Product: Top Drive Applies to: See Models Affected section	October 30, 2013
Product Bulletin # TD134

## **Top Drive Hydraulic Cold Bleed Improvement**

Figure 1: 24V Automatic Cold Bleed Valve Stack (Canrig Drawing AY12201C)

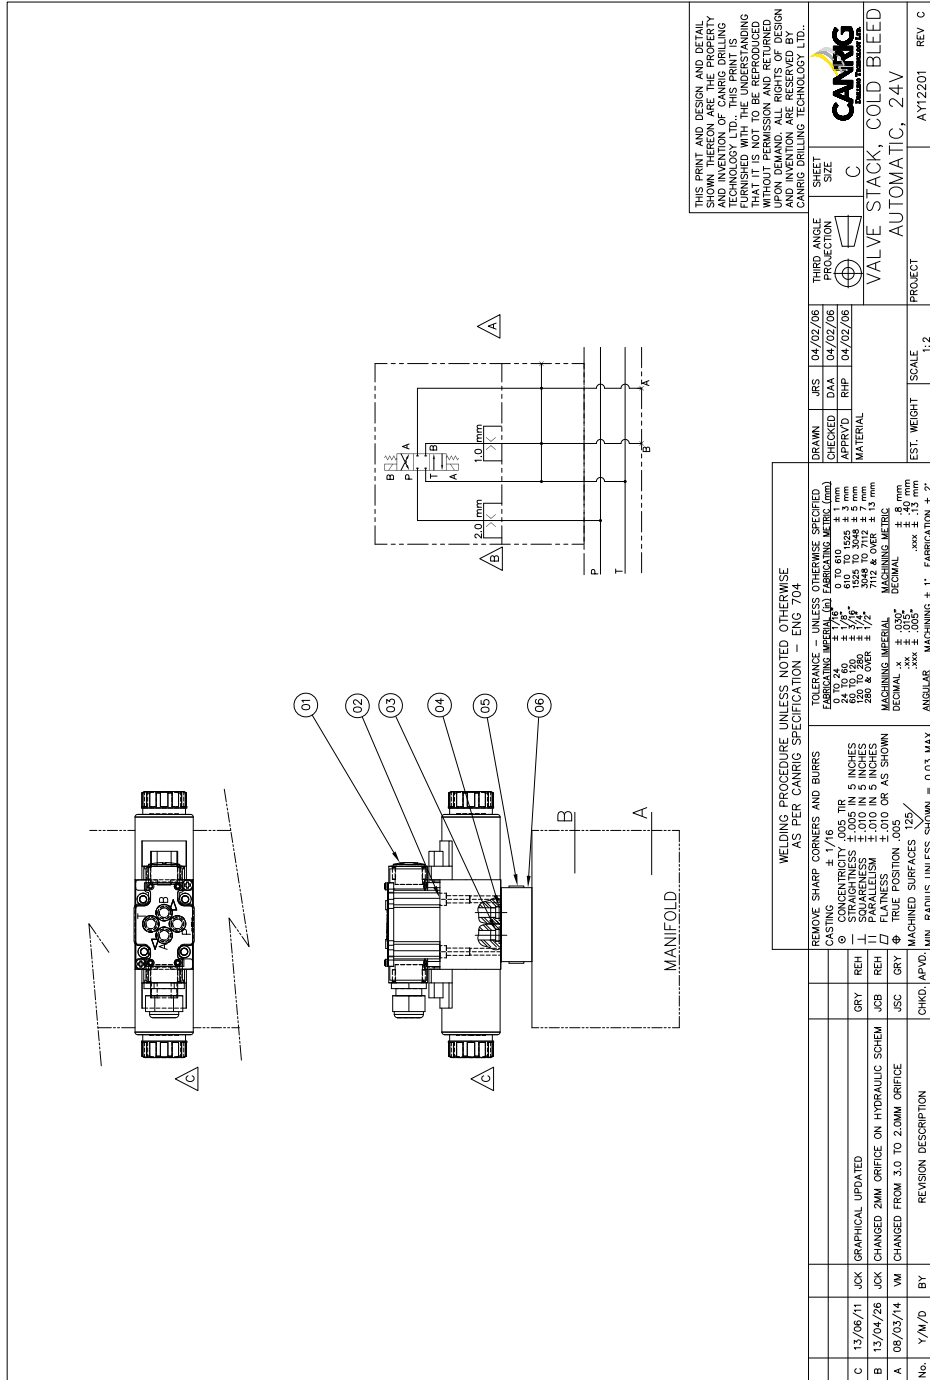
To increase resistance to erosion, the 1.75" x 2.25" x .94" aluminum manifold block (Canrig Part No. DT13605) located under the control valve is now constructed of ductile iron.

- On valve Canrig Part No. AY12201, the 3-mm orifice (Canrig Part No. H10158) has been replaced by a 2mm orifice (Canrig Part No. H10796). The orifice is now positioned on the "P" port.
- On valve Canrig Part No. AY12348, the 3-mm orifice (Canrig Part No. H10158) has been replaced by a 2mm orifice (Canrig Part No. H12480). The orifice is now positioned on the "P" port.
